Access Compliance Report

Public Rights-of-Way

(Curb Ramps)

Intersection ID: 11796	Main Street: N_PINE_ST	Cross Street: W_6TH_ST	Location: W
ADA ID: 10D26A2BB2FB	Ramp Type: PerpDiag	Initial Pass/Fail: Fail	Overall Compliance: No
		Severity Score: 62.5

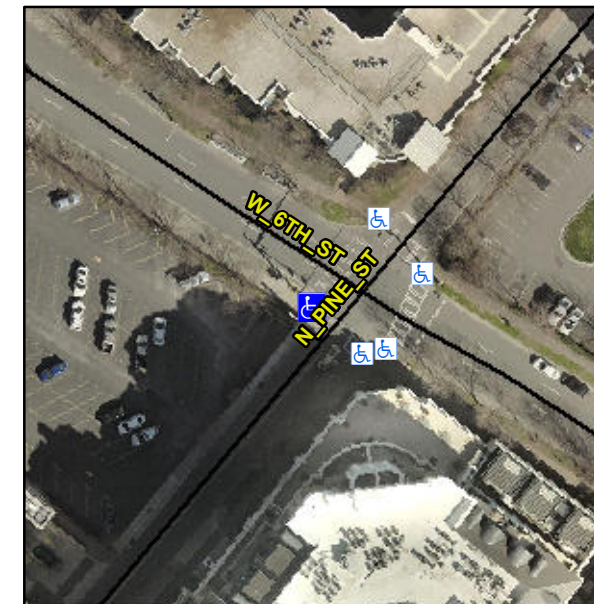
R304.5.1, R304.5.3, R302.7

Compliance	Description	Data	Compliance	Description	Data
N/A	Ramp Length (in)	86.0	Yes	Ramp Slope (%)	5.4
No	Ramp Width (in)	25.0	No	Ramp XSlope (%)	5.8
N/A	Flare Type LT	N/A	N/A	Flare Type RT	N/A
N/A	Flare Slope LT (%)	N/A	N/A	Flare Slope RT (%)	N/A
N/A	Flare Traversable LT?	N/A	N/A	Flare Traversable RT?	N/A
N/A	Landing Length (in)	N/A	N/A	DWS Provided?	N/A
N/A	Landing Width (in)	N/A	N/A	DWS Contrast?	N/A
N/A	Landing Slope (%)	N/A	N/A	DWS Length (in)	N/A
N/A	Landing X Slope (%)	N/A	N/A	DWS Full Width?	N/A
N/A	Landing Curb? (Y/N)	N/A	N/A	DWS Offset (in)	N/A
N/A	Shared Landing?	N/A			
N/A	Gutter Ponding?	N/A	N/A	Gutter Slope (%)	N/A
N/A	Gutter Lip Ht (in)	N/A	N/A	Gutter X Slope (%)	N/A
N/A	Painted X Walk1?	Yes	N/A	Painted X Walk2?	Yes
	X Walk 1 Direction	To SE		X Walk 2 Direction	To NE
N/A	X Walk 1 Width (in)	84.0	N/A	X Walk 2 Width (in)	108.0
	X Walk 1 Slope (%)	5.5		X Walk 2 Slope (%)	1.3
	X Walk 1 X Slope (%)	1.5		X Walk 2 X Slope (%)	2.4

N/A	Ramp inside XWalk1?	Yes	N/A	Ramp inside XWalk2?	Yes
	Road Slope (%)	2.4	N/A	Clear Space?	N/A
	Road X Slope (%)	2.8	N/A	Clear Space to XWalk (in)	N/A
N/A	Any Obstructions?	N/A	N/A	Storm Grate/Utility Hazard?	N/A
	Obstruction Type			Storm Grate/Utility Type	
		N/A			N/A
		No		Surface Condition? (G/P)	Poor

Remove & Replace Curb Ramp With Two New Directional Ramps or Equivalent.
